RE: **Drive Thru Restaurant**  
**700 Coors Blvd NW**  
**Grading Plan Stamp Date: 5/15/20**  
**Hydrology File: J11D039**

RE: 700 Coors Blvd NW Albuquerque, NM 87105  
**Hydrology File No. J11D039**

**DUTCH BROS COFFEE**

Drawing No. **GD1.0**

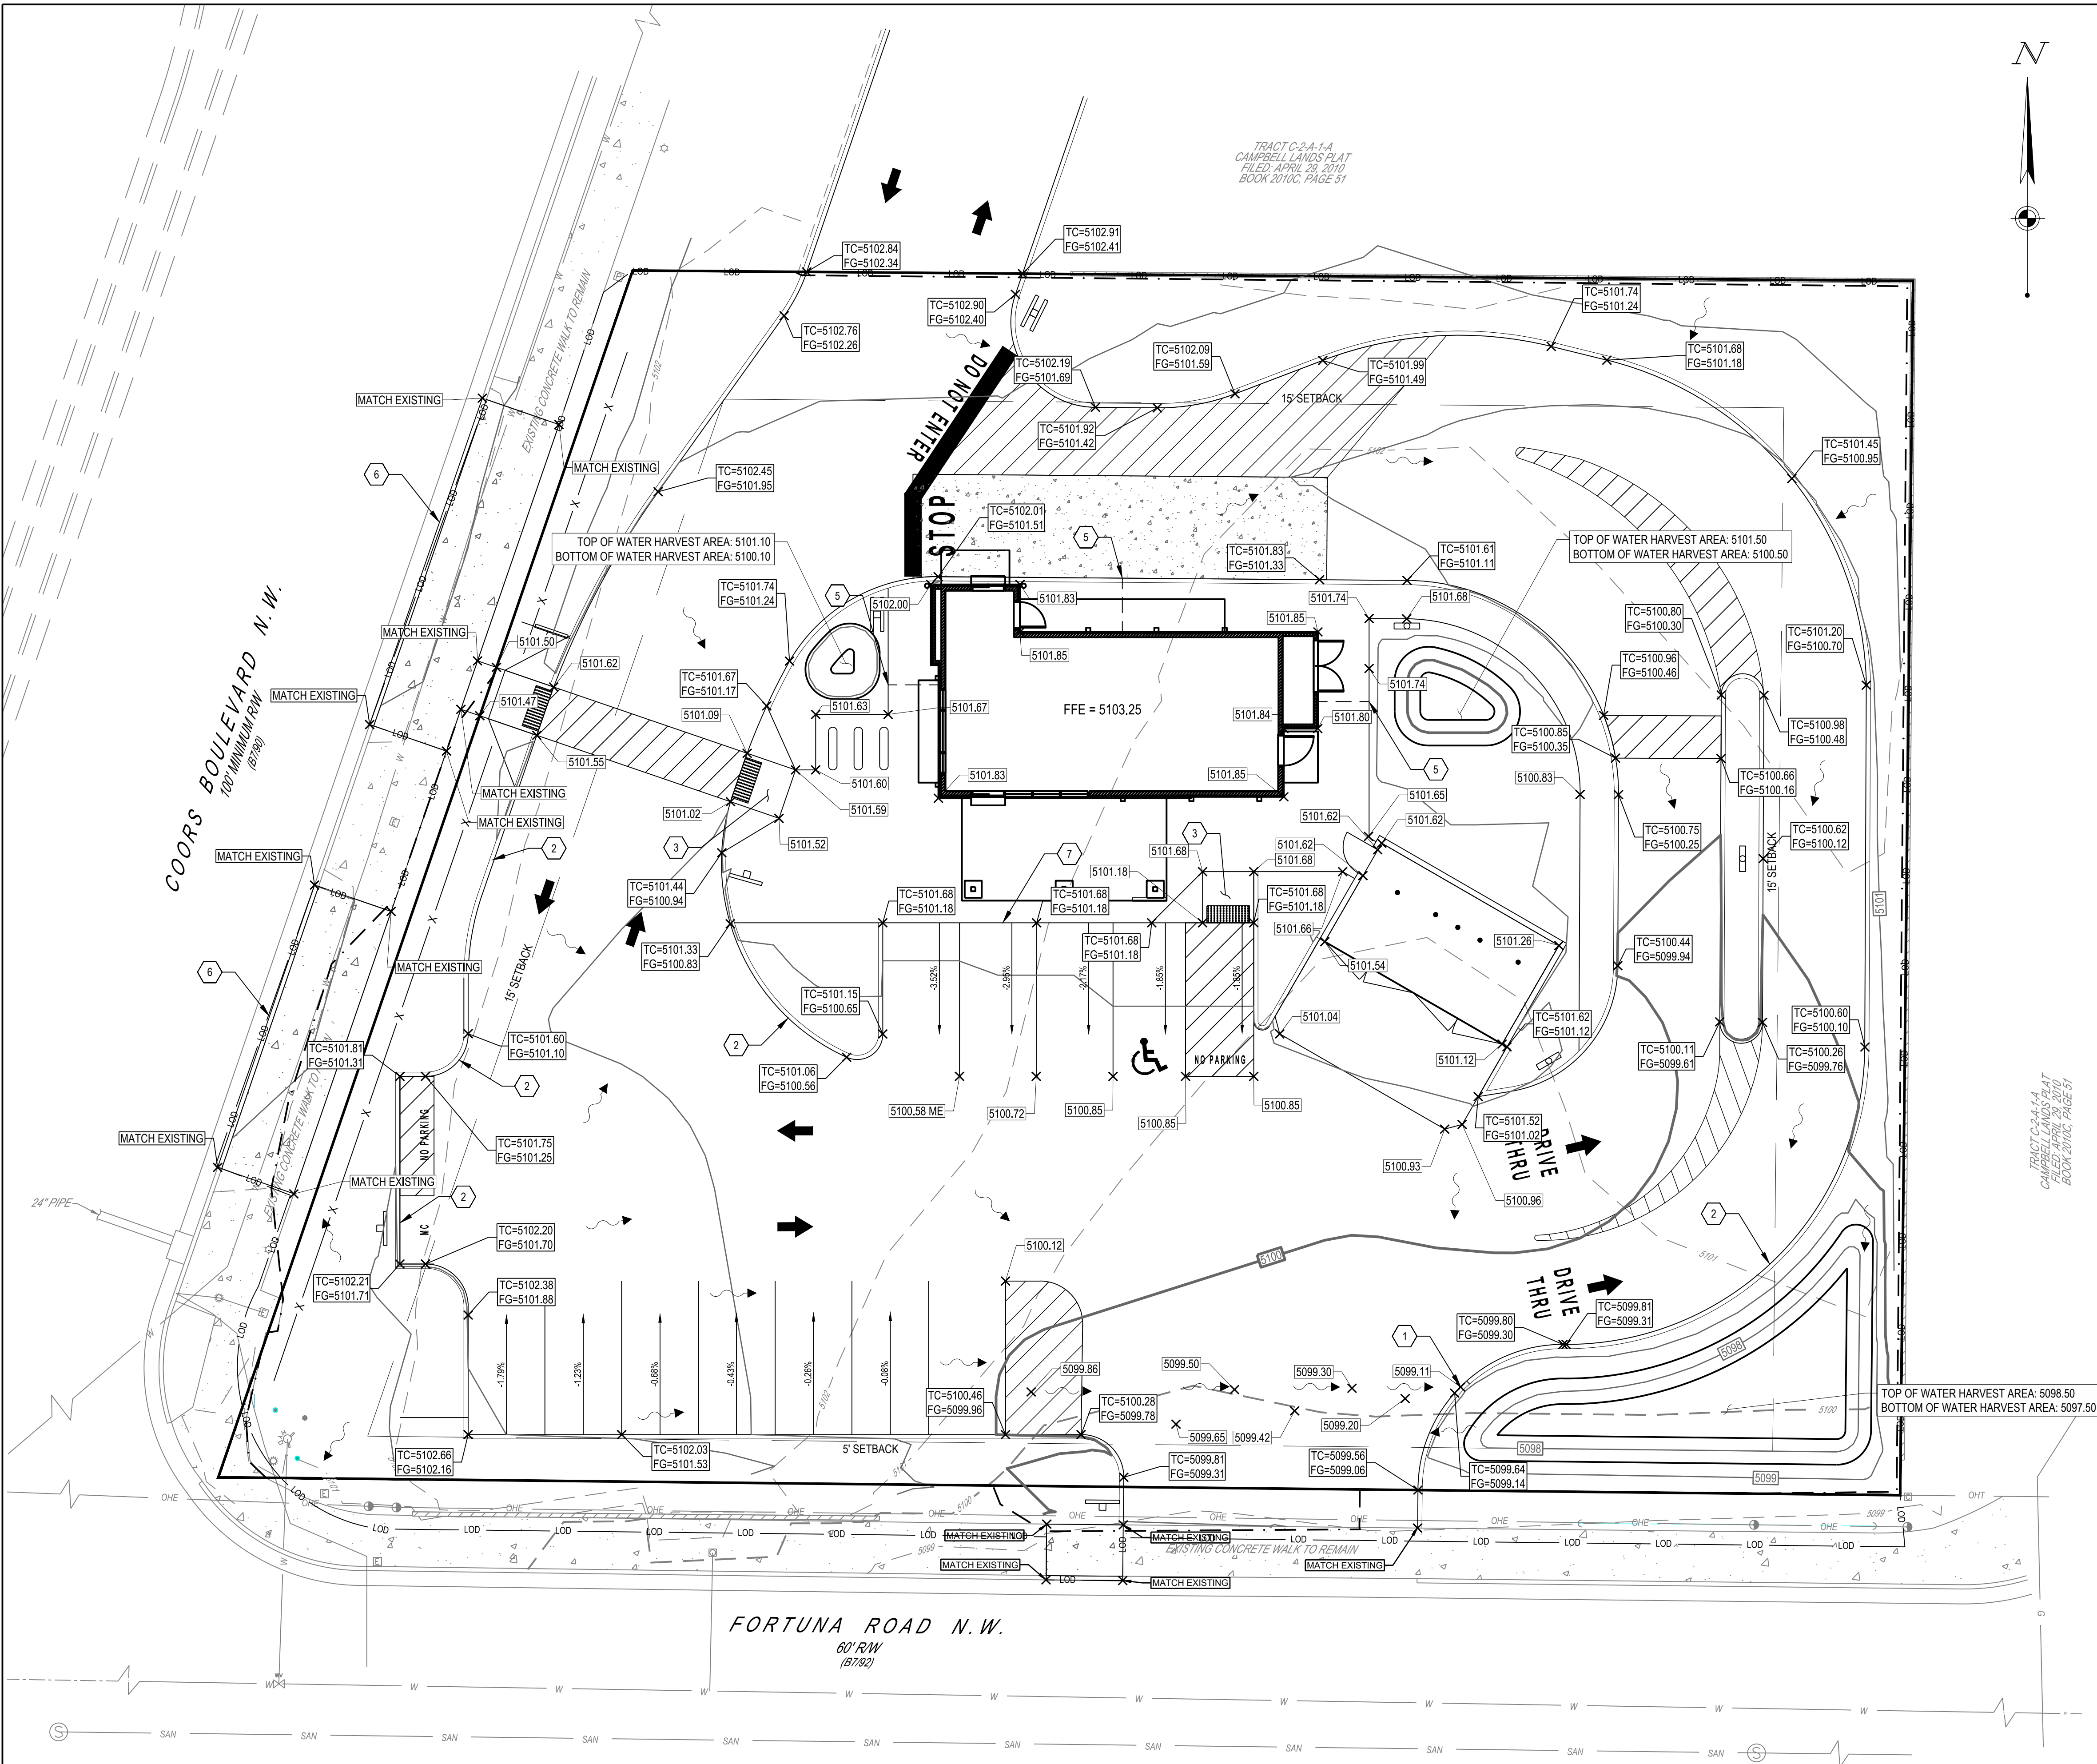
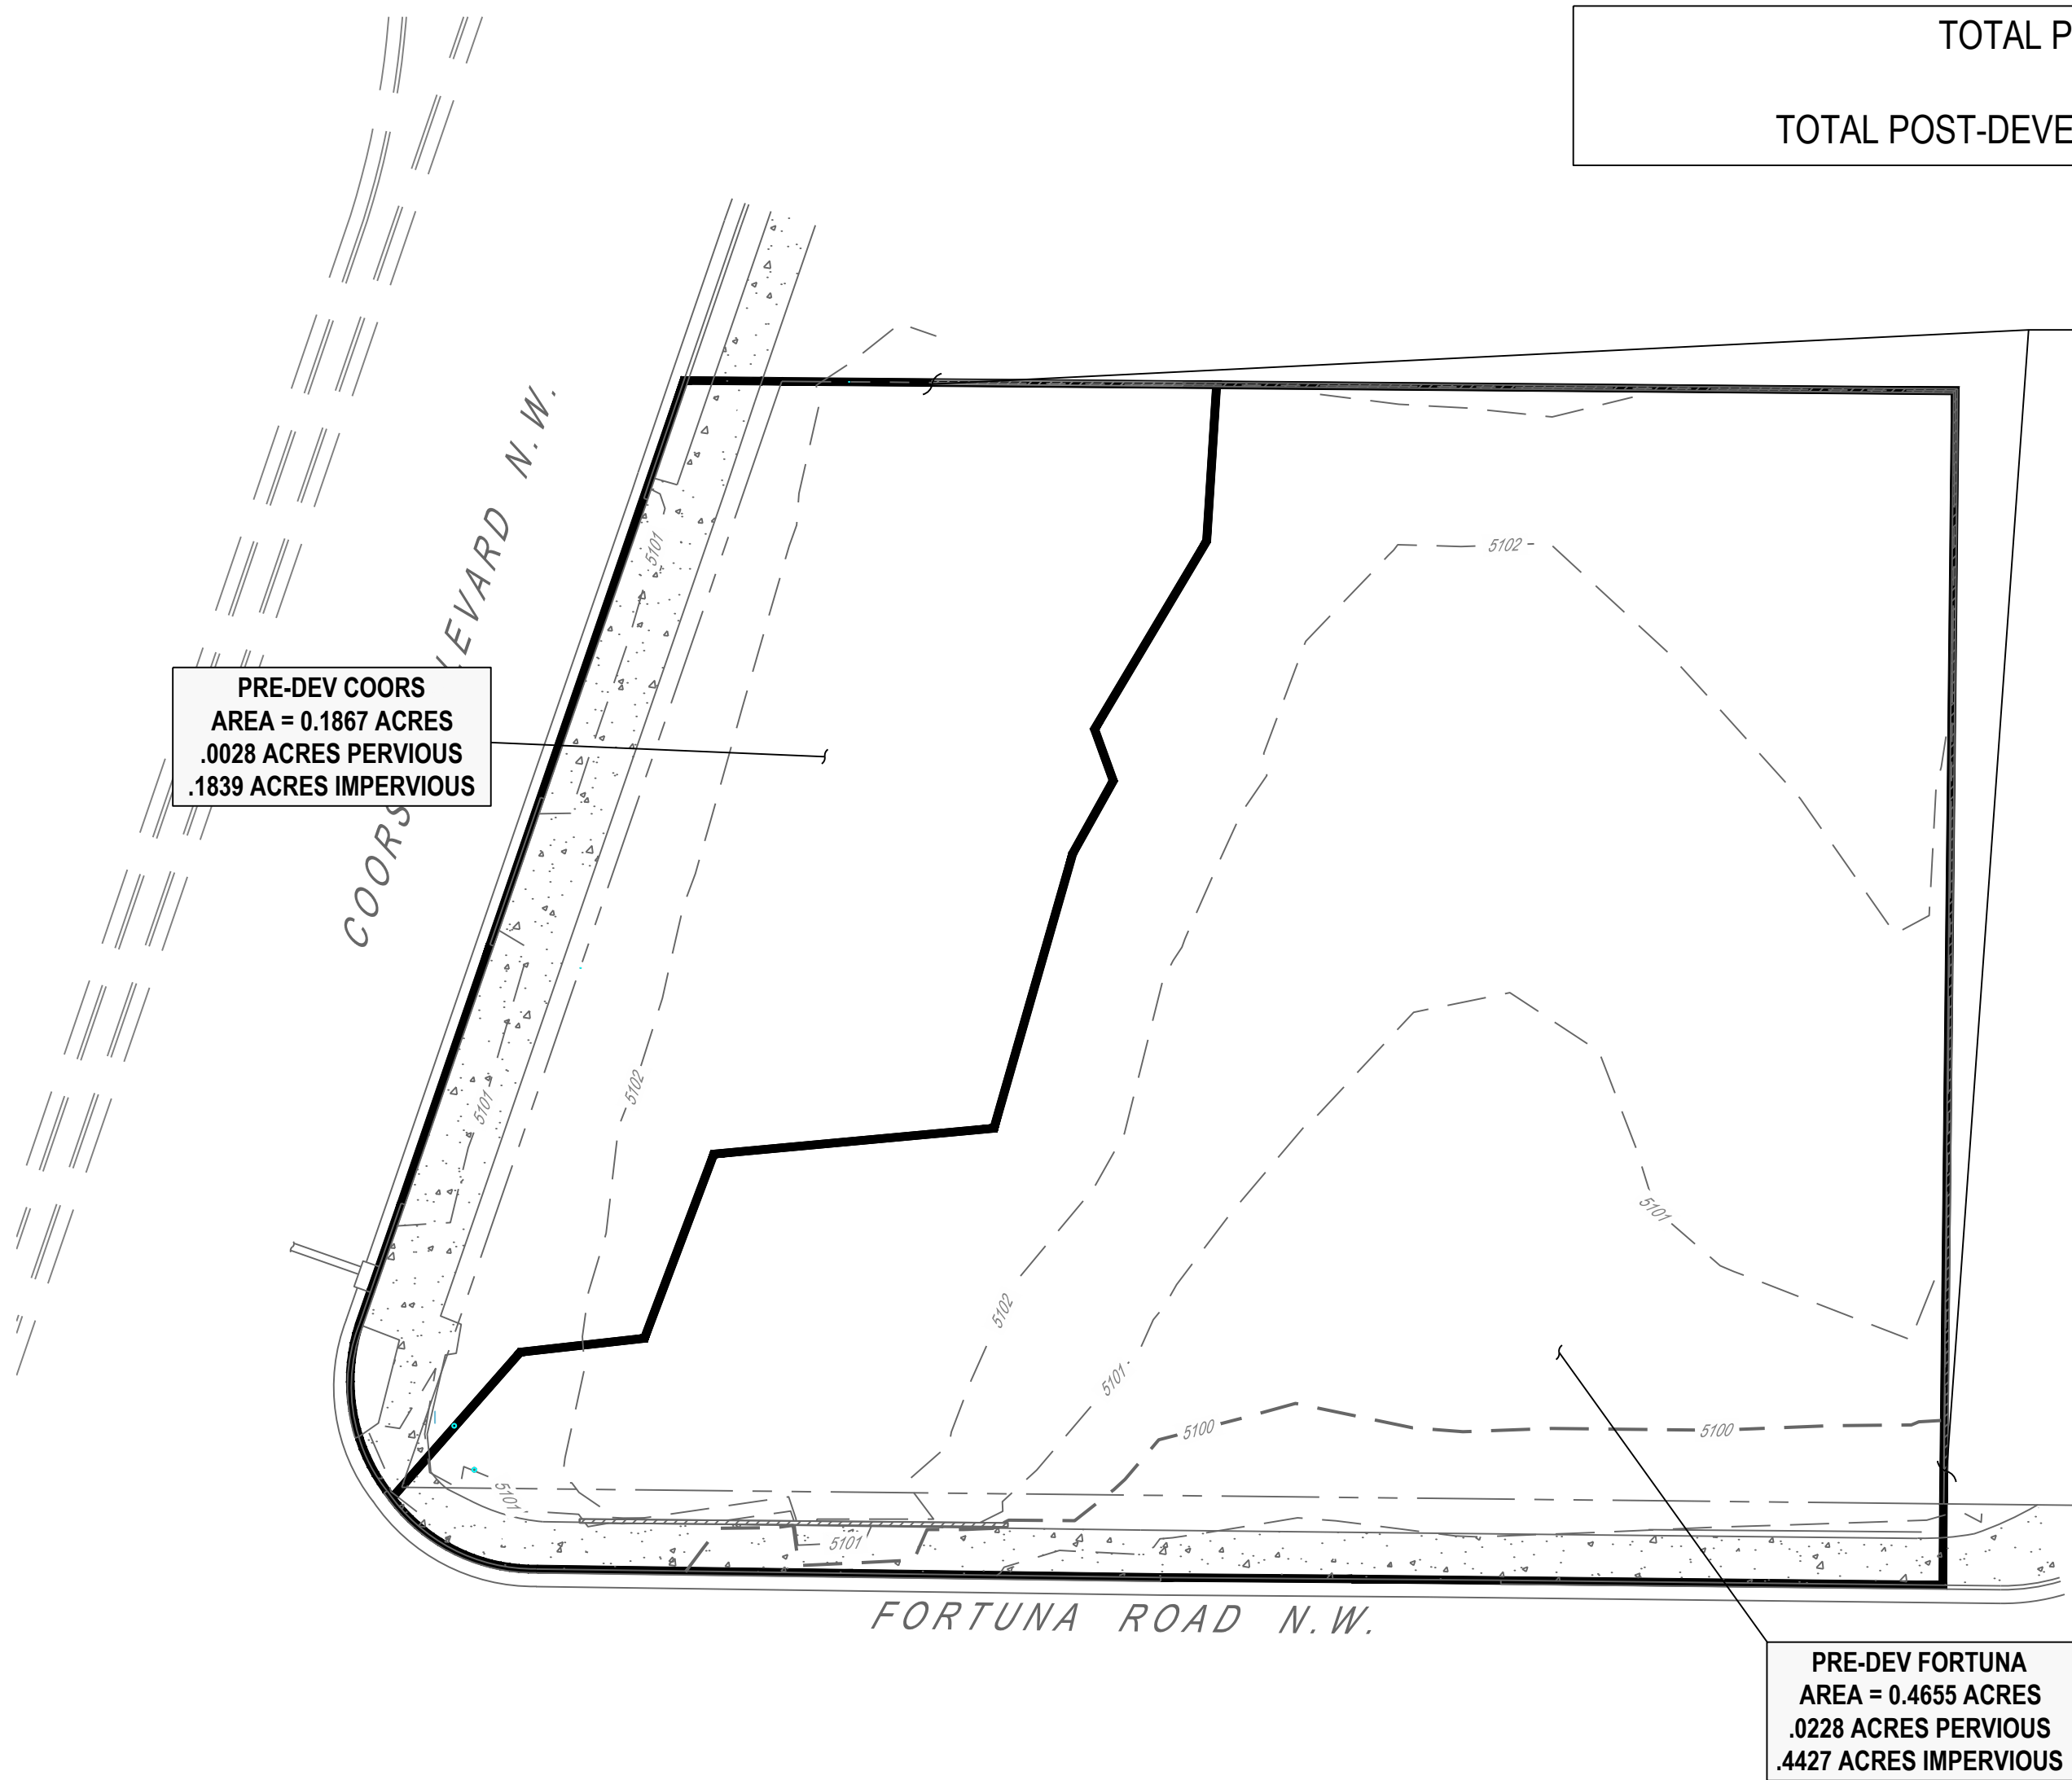
1. Runoff from impervious areas needs to be routed into the stormwater quality (SWQ) ponds. Please provide the SWQ volume calculations for each basin draining to each pond. The stormwater quality ponds need to be sized for the areas draining to them. It appears a large portion of the parking lot and roof simply flows out the driveway onto Fortuna.

7. Show the work to close the extra driveway cut, reconstruct the remaining two driveways per ADA requirements, and any other work required in the ROW. Include spot elevations at flowline and highpoint, demonstrating a 0.87' (min.) waterblock.

8. Add a note on the Grading Plan, "Prior to any work within the New Mexico Department of Transportation (NMDOT) Right-of-Way, an NMDOT permit will be required." Provide a copy of the issued permit prior to requesting Certificate of Occupancy.

**Response: Stormwater Quality ponds have been added to the site to comply with City regulations. See Sheet GD1.0 and GD1.1 for reference.**

**Response: Spot elevations and notes to close extra driveway cuts have been added to sheet GD1.0 per comment.**

**Response: Note added to Sheet GD1.0 per comment.**
